City of El Paso – City Plan Commission Staff Report

Case No: SUSU13-00034 – Delta Divine
Application Type: Resubdivision Combination
CPC Hearing Date: June 27, 2013

ATTACHMENT 3

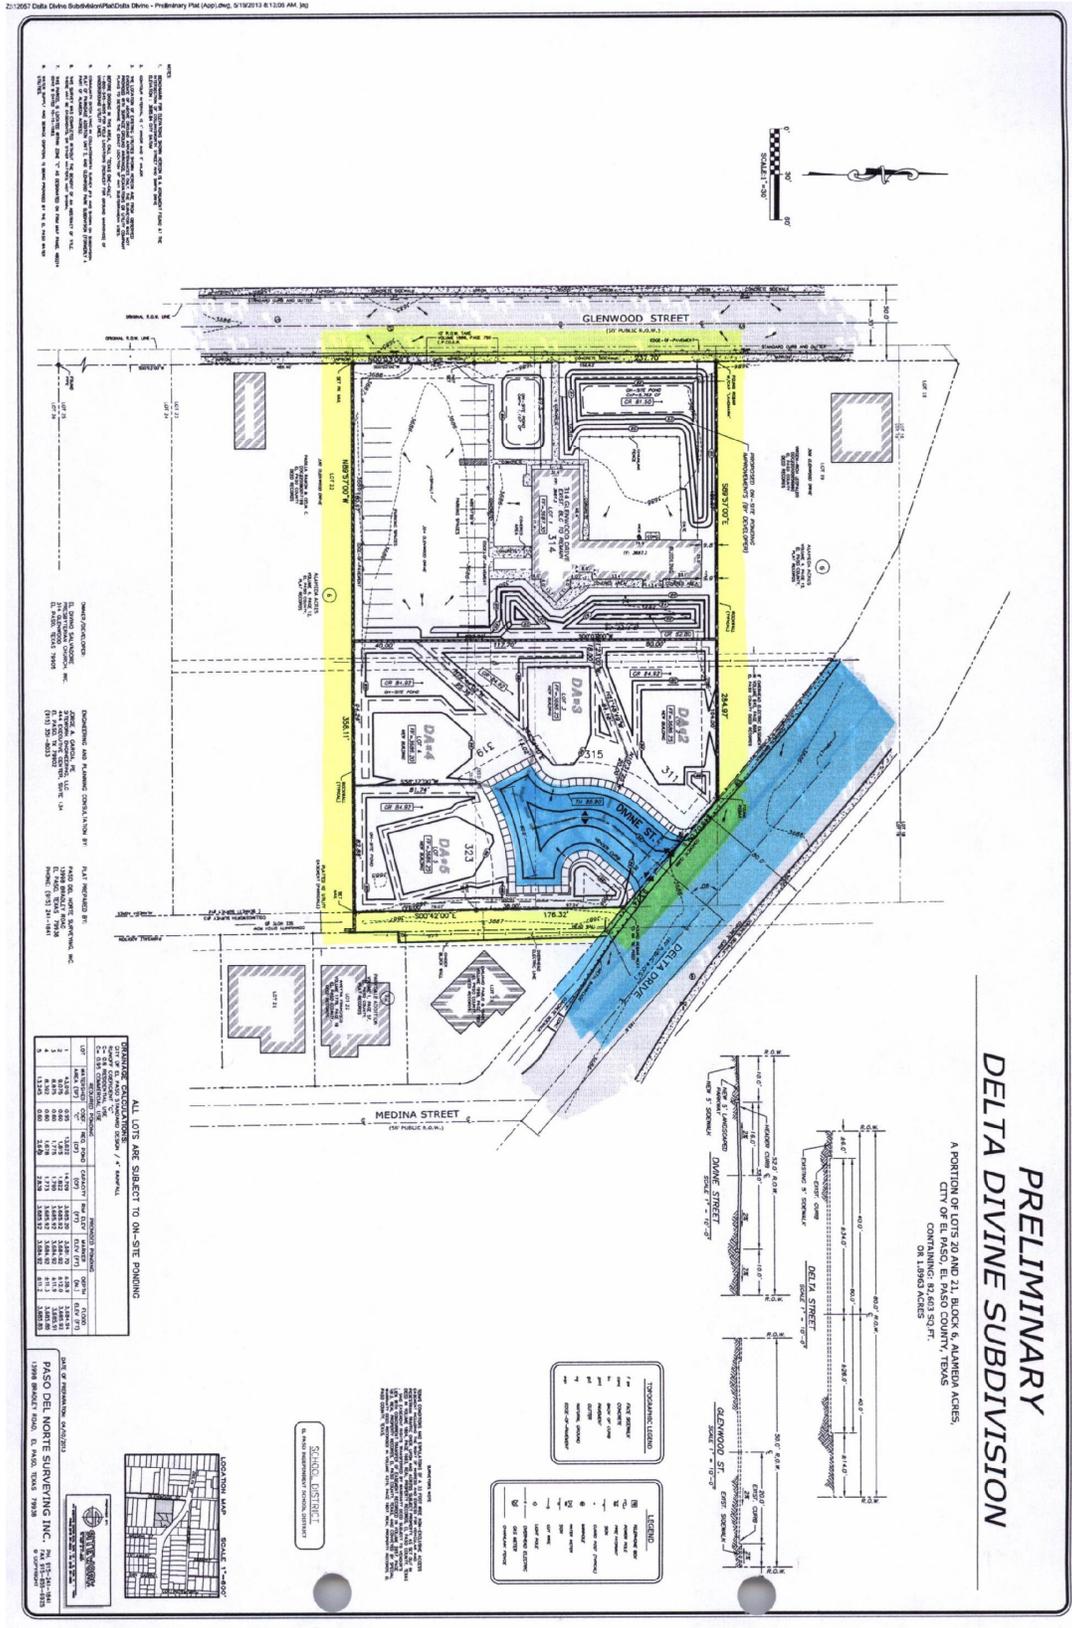
1. Missing pond labels for lots 2 & 3 on Preliminary Plat.
2. Include the following on-site ponding requirements from Section 19.16.060 as notes on the final plat.
3. EPWU recommends using principles of low impact development (such as recessed landscaping, rainwater harvesting, and porous pavements) to reduce the amount of developed stormwater runoff.

2. There is an existing 8-inch diameter water main along Glenwood St. approximately 4 feet west of the subject west property line. This main is available for service.

3. There is an existing 6-inch diameter water main along Delta St. This water main is available for service.

4. A water main extension along Devine St. will be required from the existing 6-inch diameter water main along Delta Dr. to provide water service to the lots 2-5 of the proposed subdivision. The Owner/Developer is responsible for the costs of any necessary extension.

5. EPWU records indicate an active 1-inch water meter serving the subject property. The service address for this meter is 314 S. Glenwood St. and is located off Delta Dr. This water meter serving Lot 1 will have to be relocated to Glenwood St. The Owner/Developer is responsible for the costs of relocation.

6. There is an existing 8-inch diameter sanitary sewer main along Glenwood St. The main is located approximately 19 feet west of the subject western property line. This sanitary sewer main is available for service.

7. There is an existing 8-inch diameter sanitary sewer main along Delta Dr. This main extends along Delta Dr. approximately 160 feet west from Medina St. west right of way line

8. There is an existing 12-inch diameter force main along Delta Dr. No direct service connections are allowed to this sanitary sewer main as per the El Paso Water Utilities – Public Service Board Rules and Regulations.

9. A sanitary sewer main extension along Devine St. from the existing 8-inch diameter sanitary sewer main that extends along Delta Dr. will be necessary to provide sanitary service to the proposed subdivision. The Owner/Developer is responsible for the costs of any necessary extension.

10. The location of the sanitary sewer service connection to lot 1 is unknown.

11. There is an existing 24-inch diameter reclaimed water main (non-potable) along Delta St. approximately 6 feet from the back of curb.
